Access Compliance Report Public Rights-of-Way (Curb Ramps)

Main Street: YORBA_ST Cross Street: SANTA_CLARA_AVE Location: SW

ADA ID: RPRK220127120721 Ramp Type: Type 4 - Parallel Initial Pass/Fail: Fail Overall Compliance: No Severity Score: 2

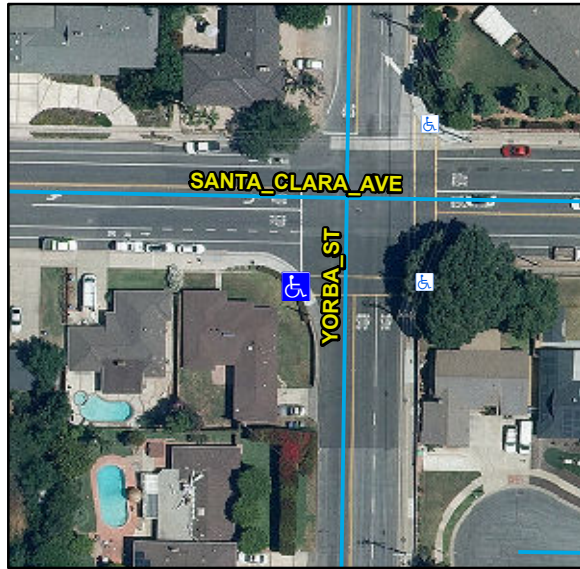
Compliance	Description	Data	Compliance	Description	Data
N/A	Ramp Length LT (in)	83	N/A	Ramp Length RT (in)	86
Yes	Ramp Width LT (in)	48	Yes	Ramp Width RT (in)	48
Yes	Ramp Run Slope LT (%)	1.8	Yes	Ramp Run Slope RT (%)	7
No	Ramp Cross Slope LT (%)	2.2	No	Ramp Cross Slope RT (%)	2.1
N/A	Landing Present	N/A	N/A	DWS Provided	N/A
N/A	Landing Length (in)	N/A	N/A	DWS Contrast	N/A
N/A	Landing Width (in)	N/A	N/A	DWS Length (in)	N/A
N/A	Landing Run Slope (%)	N/A	N/A	DWS Full Width	N/A
N/A	Landing Cross Slope (%)	N/A		DWS Offset Type	N/A
N/A	Landing Movement Obstructed?	N/A	N/A	DWS Offset Left (in)	N/A
	Landing Movement Type	N/A	N/A	DWS Offset Right (in)	N/A
N/A	Landing Shared	N/A			
N/A	Clear Space	Yes			
N/A	Clear Space To Crosswalk (in)	N/A			
N/A	Marked Crosswalk 1	Yes	N/A	Marked Crosswalk 2	No
	Crossing 1 Direction	E		Crossing 2 Direction	N
	Marked Crosswalk 1 Width (in)	144		Marked Crosswalk 2 Width (in)	N/A
N/A	Ramp Inside Crosswalk 1	Yes	N/A	Ramp Inside Crosswalk 2	N/A

Remove & Replace Curb Ramp With Two New Directional Ramps or Equivalent.
